PRELIMINARY PLAN
WILGUS TRACT
120200140

RE: Preliminary Plan and Design Exceptions
Preliminary Plan No. 120200140
Wilgus

We have completed our review of the revised preliminary plan uploaded to eplans on April 21, 2020. A previous version of this plan was reviewed by the Development Review Committee (DRC) at its meeting on March 17, 2020. We recommend approval of the plan subject to the following comments:

Cherington Review of Wilgus Preliminary Plan Submission, March 12, 2020

PLANNING DEPARTMENT USE ONLY (E-PLANS)

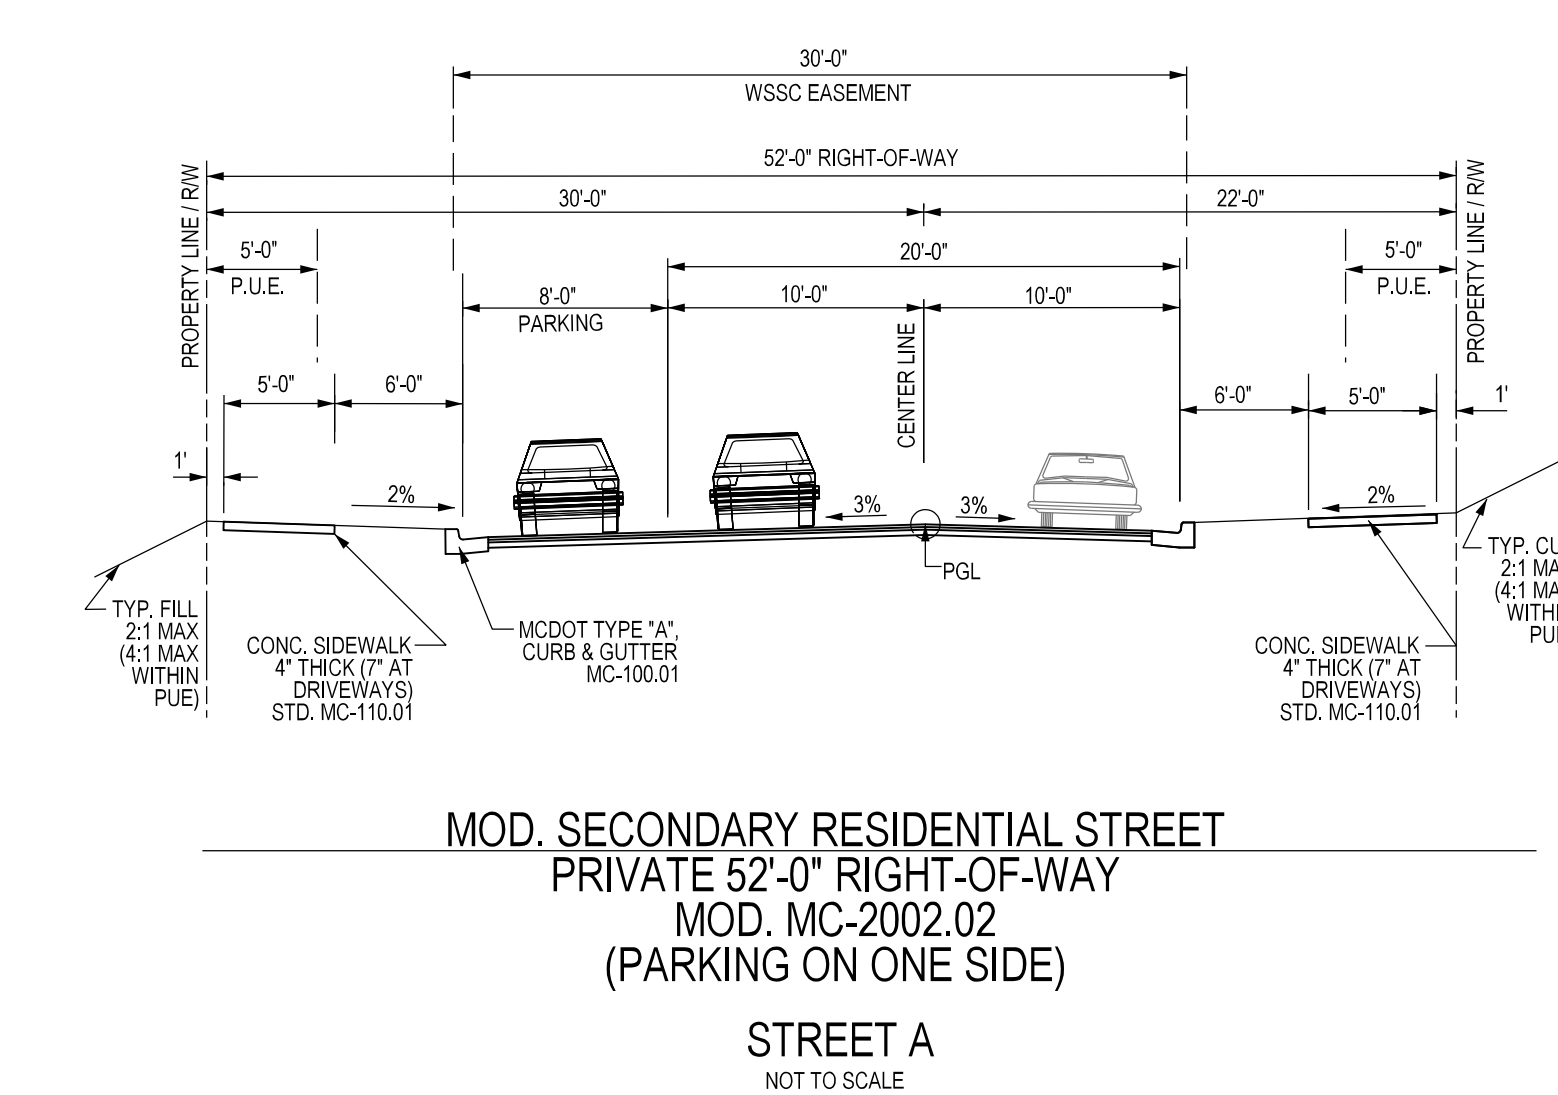
1. A-1 - Modification of Context Sensitive Road Section – Stonehenge Place (B-2): The applicant is proposing to modify MCDOT Standard No. MC-2005.02, maintaining the full 70-foot right-of-way, but reducing the sidewalk and increasing the tree panel. The applicant is proposing the following street section:
 - 2-foot maintenance strip
 - 5-foot sidewalk
 - 9-foot stormwater management/tree panel
 - 8-foot parking section
 - two 11-foot travel lanes
 - 8-foot parking section
 - 9-foot stormwater management/tree panel
 - 5-foot sidewalk
 - 2-foot maintenance strip

2. A-2 - Modification of Context Sensitive Road Section-Public Street C (Station 0+00 to Station 2+50):
The applicant is proposing to modify MCDOT Standard No. MC-2005.01 from a 60-foot to a 55-foot right-of-way by placing some sidewalk outside the right-of-way in a P.I.E., eliminating the 1.5-foot curb offset but increasing the tree panel. The applicant is proposing the following street section:

3. A-3 - Modification of Context Sensitive Road Section-Public Street C (Station 2+50 to Station 5+01):
The applicant is proposing to modify MCDOT Standard No. MC-2005.01 from a 60-foot to a 55-foot right-of-way by moving the outside edges of the sidewalks to the right-of-way line, providing a P.I.E. for sidewalk maintenance, eliminating the 1.5-foot curb offset but increasing the tree panel. The applicant is proposing the following street section:

MCDOT Response: MCDOT **approves** this Design Exception. The proposed road is shown in the master plan, and the applicant is meeting the urban road code standards. The applicant's proposed section will provide more space for stormwater management treatment while maintaining walkability and meeting minimum ADA standards.

MCDOT Response: MCDOT **approves** this Design Exception. The proposed street is not shown in the master plan, and the applicant is meeting the urban road code standards. The applicant's proposed section will provide more space for stormwater management treatment while maintaining walkability and meeting minimum ADA standards.

MCDOT Response: MCDOT **approves** this Design Exception. The proposed street is not shown in the master plan, and the applicant is meeting the urban road code standards. The applicant's proposed section will provide more space for stormwater management treatment while maintaining walkability and meeting minimum ADA standards.
